# Access Compliance Report

## Public Rights-of-Way

### (Curb Ramps)

Intersection ID: 26626	Main Street: TRAPPERS_CREEK_CT	Cross Street: WINTHROP_RIDGE_RD	Location: W
ADA ID: 4F25990D6149	Ramp Type: Perp	Initial Pass/Fail: Fail	Overall Compliance: No
Severity Score: 10			
Codes/Mitigation Info/Possible Solution		Field Measurements/Component Compliance

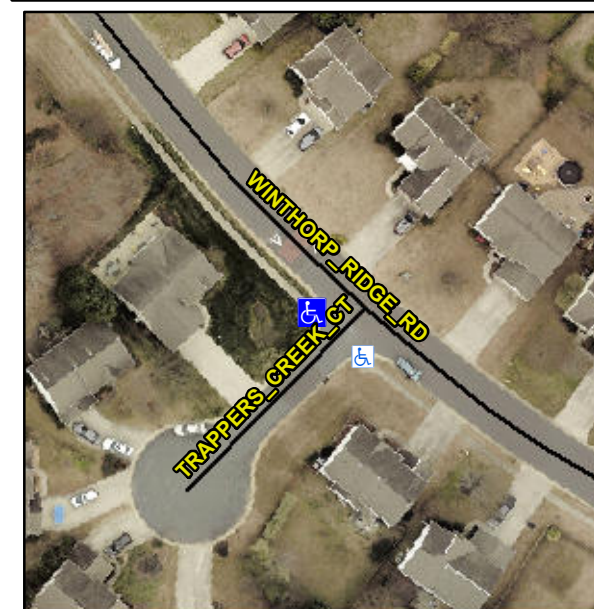
**Not Found, R304.5.1, R304.5.3**

Compliance	Description	Data	Compliance	Description	Data
N/A	Ramp Length (in)	96.0	Yes	Ramp Slope (%)	5.2
No	Ramp Width (in)	40.0	No	Ramp XSlope (%)	4.2
N/A	Flare Type LT	N/A	N/A	Flare Type RT	N/A
N/A	Flare Slope LT (%)	N/A	N/A	Flare Slope RT (%)	N/A
N/A	Flare Traversable LT?	N/A	N/A	Flare Traversable RT?	N/A
N/A	Landing Length (in)	N/A	N/A	DWS Provided?	N/A
N/A	Landing Width (in)	N/A	N/A	DWS Contrast?	N/A
N/A	Landing Slope (%)	N/A	N/A	DWS Length (in)	N/A
N/A	Landing X Slope (%)	N/A	N/A	DWS Full Width?	N/A
N/A	Landing Curb? (Y/N)	N/A	N/A	DWS Offset (in)	N/A
N/A	Shared Landing?	N/A			
N/A	Gutter Ponding?	N/A	N/A	Gutter Slope (%)	N/A
N/A	Gutter Lip Ht (in)	N/A	N/A	Gutter X Slope (%)	N/A
N/A	Painted X Walk1?	No	N/A	Painted X Walk2?	N/A
	X Walk 1 Direction	To SE		X Walk 2 Direction	N/A
N/A	X Walk 1 Width (in)	N/A	N/A	X Walk 2 Width (in)	N/A
	X Walk 1 Slope (%)	3.7		X Walk 2 Slope (%)	N/A
	X Walk 1 X Slope (%)	4.8		X Walk 2 X Slope (%)	N/A

**Remove & Replace Entire Ramp.**
